☐ No Exception Taken ☐ Revise and Resubmit
☐ Rejected ☐ Submit Specified Item
☒ Furnish As Corrected

SARGENTI ARCHITECTS, P.C.

RTM Engineering Consultants, LLC

☐ REVIEWED ☐ REVISE AND RESUBMIT
☑ REVIEWED AS NOTED ☐ REJECTED

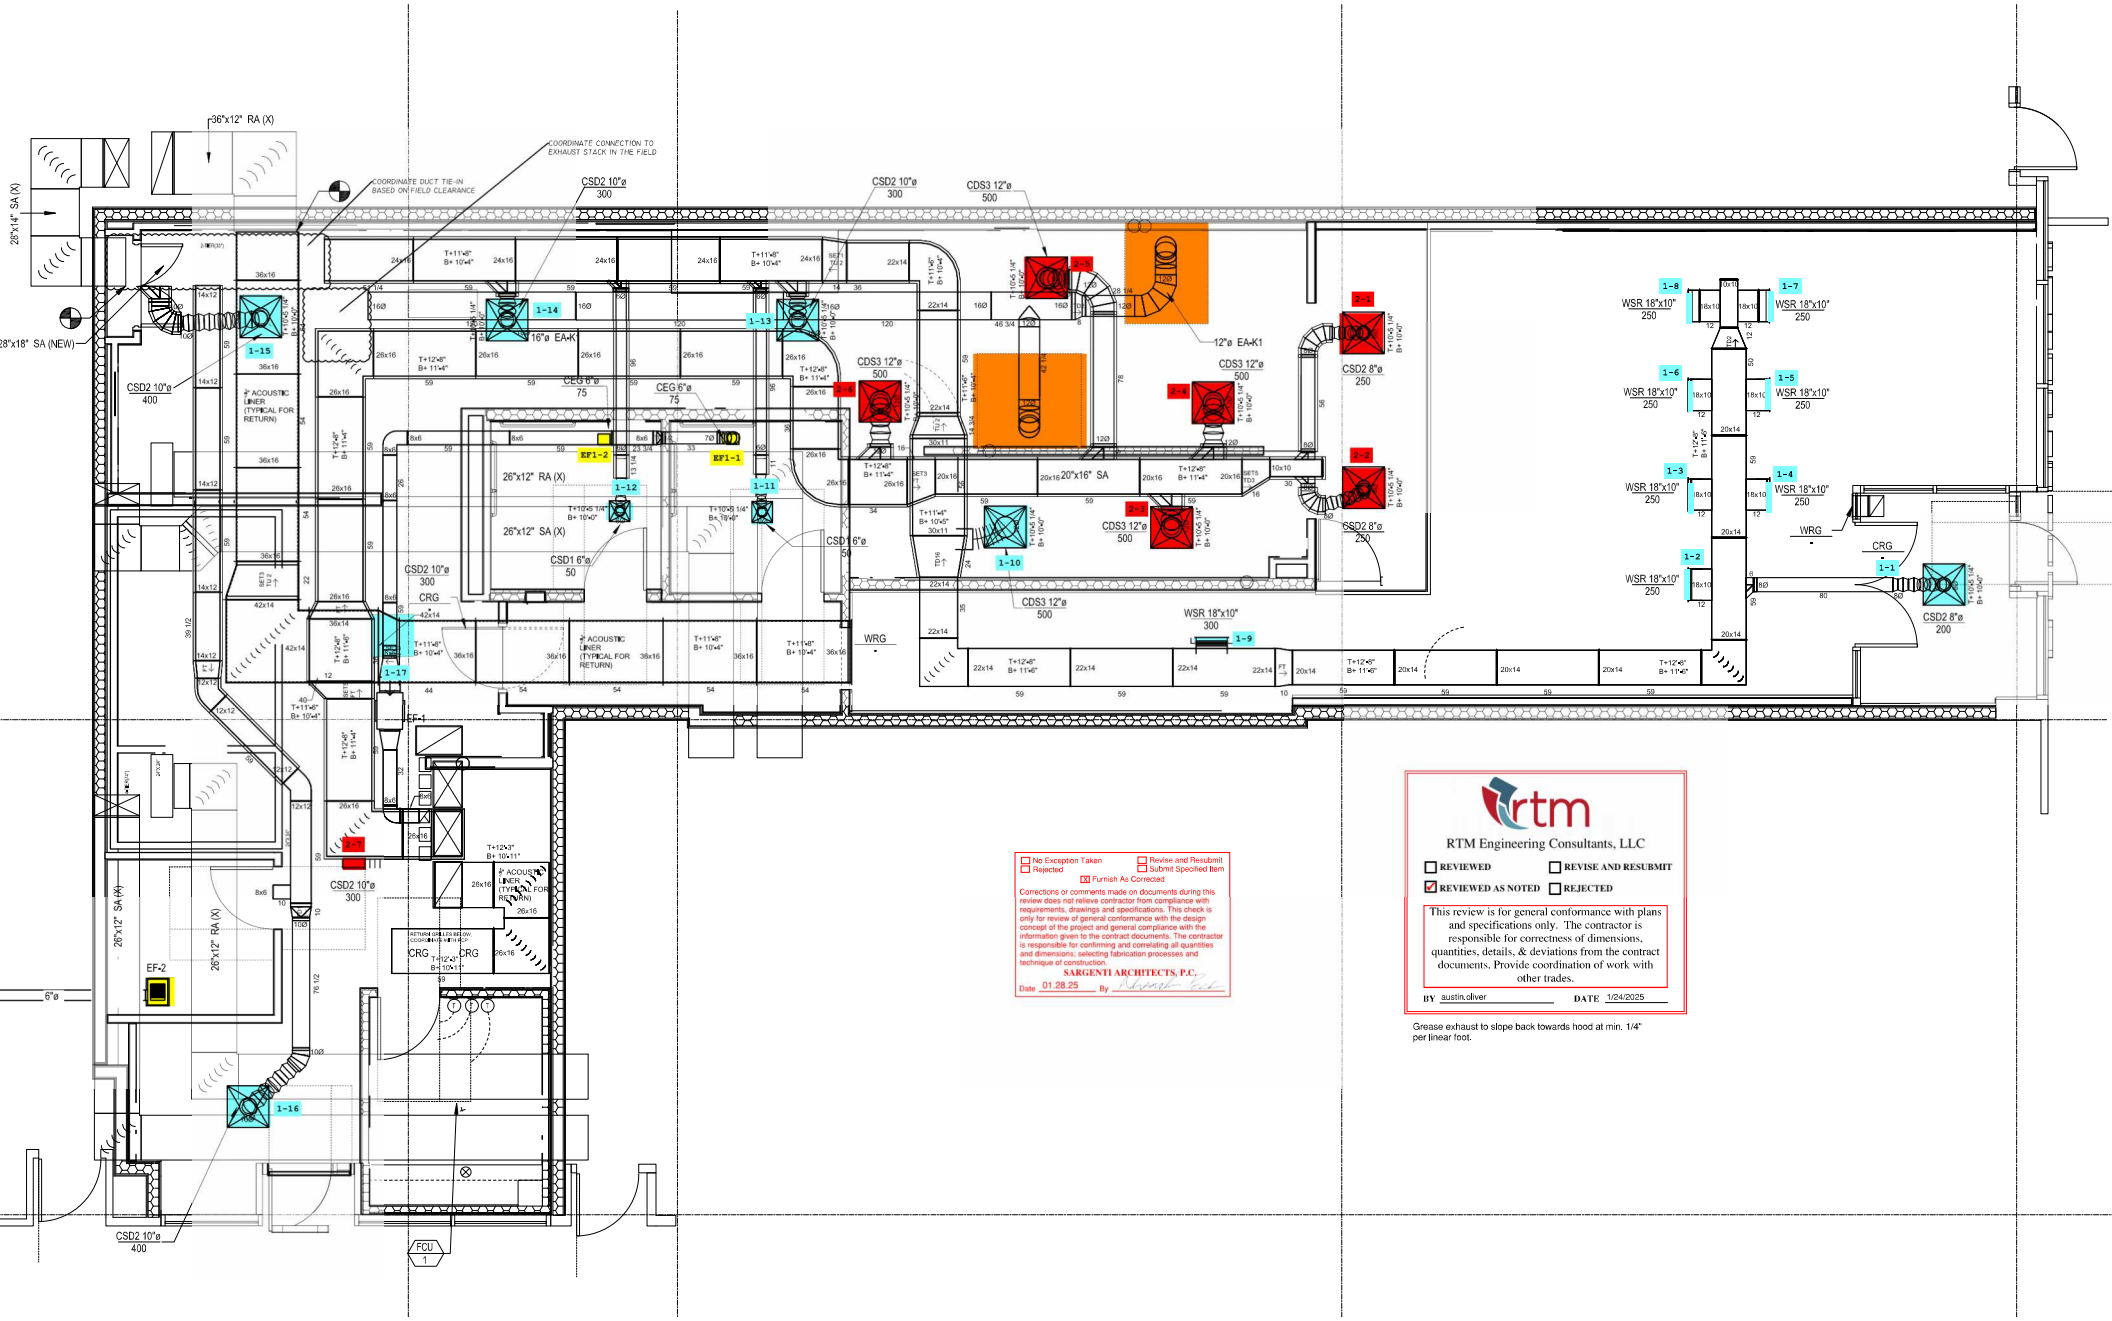
Grease exhaust to slope back towards hood at min. 1/4" per linear foot.
